**Notes on broken Ring Heater Element D1002538-v4 SN-210:**  
Due to Post-Installation Adjustment with Pliers  
(14-March-2014)

M. Jacobson  
18-March-2014

# Photos of broken pieces vs. Intended assembly

# Photos of broken pieces vs. Intended assembly

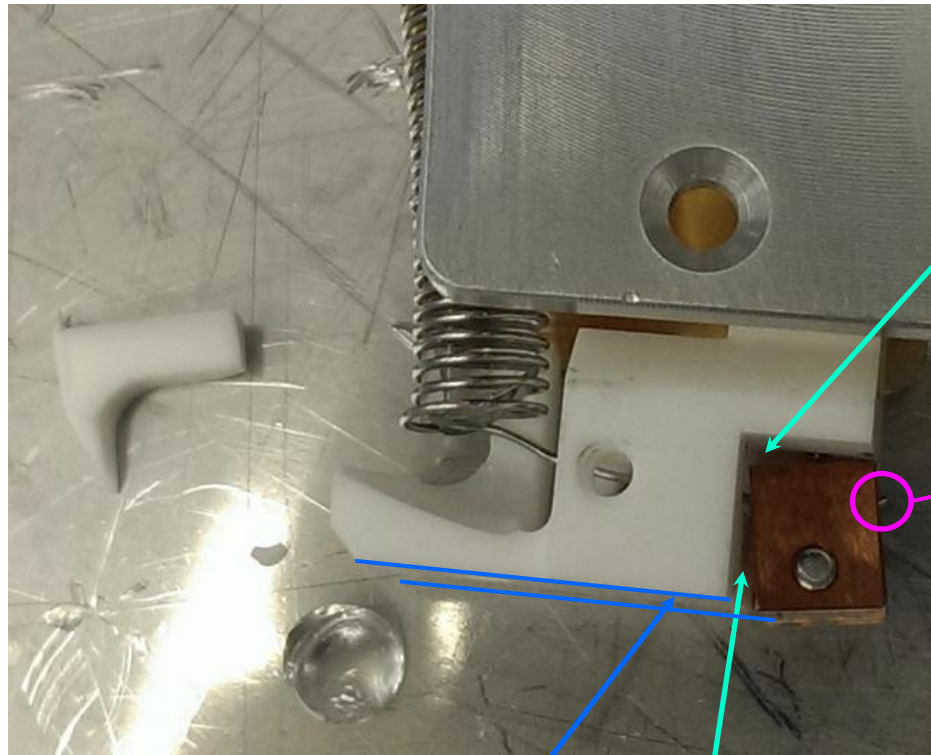
The base plane of the macor retainer is intended to be flush with the base plane of the macor retainer of the adjacent (upper) RH assembly.

These gaps were noticed by SUS, causing the copper pieces (D1200560 & D1200561) to extend beyond the base plane of the adjacent macor retainer (D1002544)

Apparently, pliers were used to “tug” at the pair of copper clamping parts.  
**NOTE:**  
This protruding free end of NiCr wire is not seated properly between the two copper clamping plates. Hence, it would not have been possible to “tug” the pieces in any way that would have reduced the gaps.
